XC18V00 PROM Errata and Deviations from XC18V00 Data Sheet

DS026-E01 (v1.1) March 10, 2004

Errata Notice

Figure 4: Recommended Resistor Value

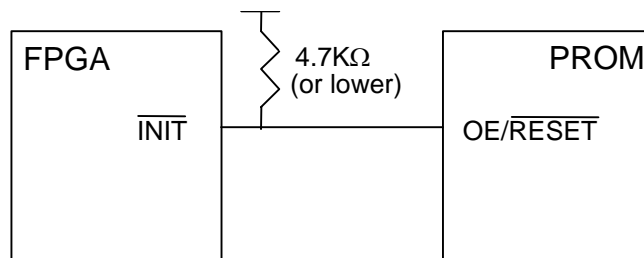
A pull-up resistor is required to properly propagate this signal through the PROM (Figure 1). Figure 2 shows a clean OE/RESET# (INIT#) signal. However, a slow ramp could potentially allow system noise to propagate through the PROM's input buffer (Figure 3), thus creating short reset pulses that might cause the internal circuits to get out of sync. The observed failure rate ranges from 1% to 5% of configuration cycles.

Follow the data sheet to ensure that an external 4.7KΩ (or lower) resistor is connected to the PROM's OE/RESET# pin and the FPGA's INIT pin. Ensure that the FPGA T_{ICCK} specification is met (500ns). This translates to a T_{RISE} and T_{FALL} time of 500 ns for the PROM's OE/RESET# signal.

Figure 8: (LED with Buffer Circuit)

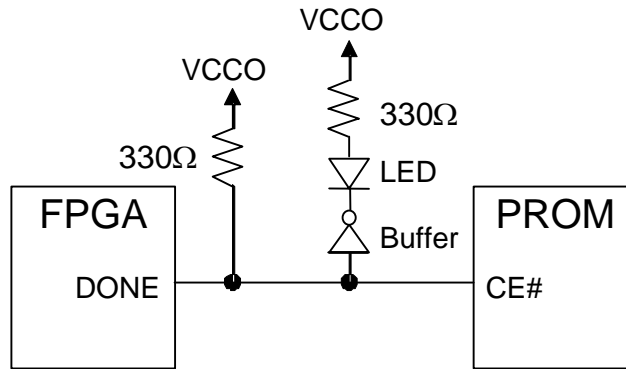
The FPGA has a sink current specification of 12 mA that is exceeded when an unbuffered LED is tied to the CE# (DONE) signal (Figure 5). In this scenario, the CE# (DONE) signal is held at an intermediate voltage level that mimics multiple input pulses (Figure 7). These pulses propagate through the PROM and cause the internal circuits to get out of sync. The observed failure rate is up to 50% of configuration cycles. Figure 6 shows a clean CE# (DONE) signal when it is not tied to an LED.

When using FPGA DONE to drive PROM CE# (to reduce standby power), make sure that the signal is within the specification and has a fast rise and fall time. Use an external buffer to drive any LED (Figure 8). If DONE is not used to drive CE#, it can be connected to an LED (Figure 9).

Figure 10: Asynchronous System

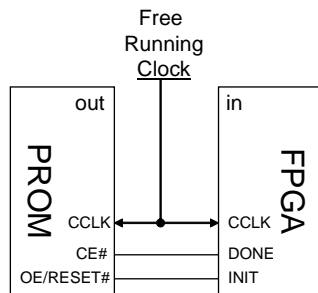
In most applications, the FPGA sources the CCLK signal, which synchronizes with the CE# (DONE) and OE/RESET# (INIT#) signals. However, in an asynchronous system (Figure 10), meaning when an external free-running clock drives the configuration clock signal (CCLK), there is a possibility that a missed or extra pulse (or pulses) can be interpreted by the PROM's internal counters as CCLK transitions while the OE/RESET# (INIT#) signal is in its intermediate phase (Figure 11). The observed failure rate ranges from 0.1% to 1% of configuration cycles.

There is no application work-around that will avoid exposure to the phenomenon when a free running clock is used. Therefore, customers who are using an external free-running clock need to convert their ordering code to SCD0799; this will ensure that they will not receive affected devices identified in Table 1, Table 2, and Table 3.

Figure 12: Counter Circuits

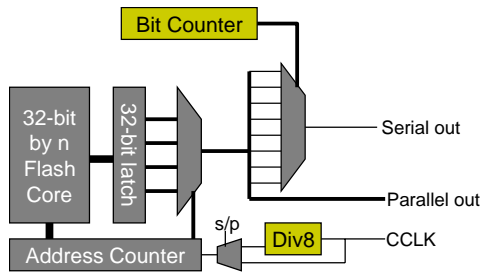
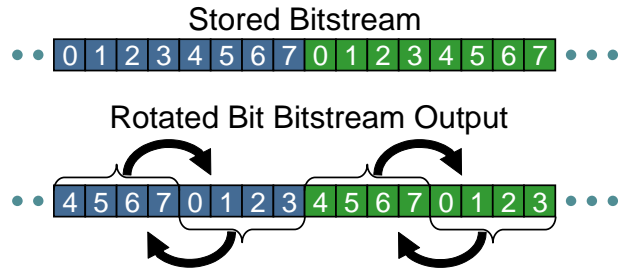
A Rotated Bit Pattern occurs when the Bit Counter and the Div8 circuit (Figure 12) becomes desynchronized. Data bits within a byte will be consistently rotated, byte by byte (Figure 13). Table 4 (above) summarizes the conditions where a Rotate Bit Pattern can occur.

FIXES			
		Add hysteresis to OE/RESET# and CE# input buffers	Re-synchronize bit and byte (div8) counters at each byte increment	Synchronize internal reset to configuration clock	Suppress re-initiation of internal reset/pre-load while a reset/pre-load is in progress
Symptoms	Rotated Bits Pattern	√	√		√
	Extra 32 Bits Pattern			√	
	Missing 32 Bits Pattern			√	
Conditions	Slow Ramp OE/RESET# (INIT#)	√	√		√
	Staircase Voltage of CE# (DONE)	√	√		√
	External Free Running Clock			√

Figure 14: Counter Circuits

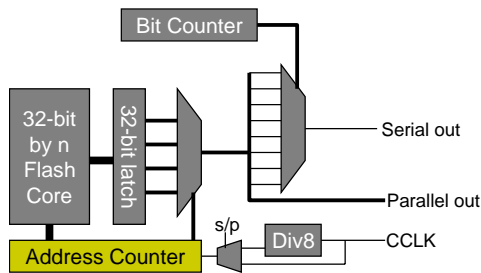
The Address Counter misses the first increment and repeats the first 32 bits. Table 4 (above) summarizes the conditions where an Extra 32 Bits pattern can occur.

Figure 16: Counter Circuits

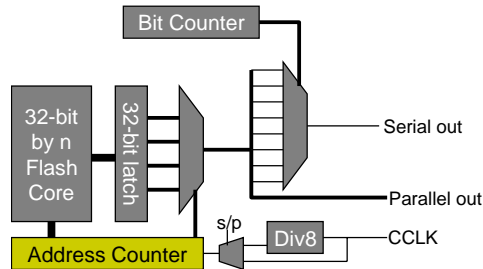
The Address Counter increments more than once and misses the second 32 bits. Table 4 (above) summarizes the conditions where a Missing 32 Bits pattern can occur.
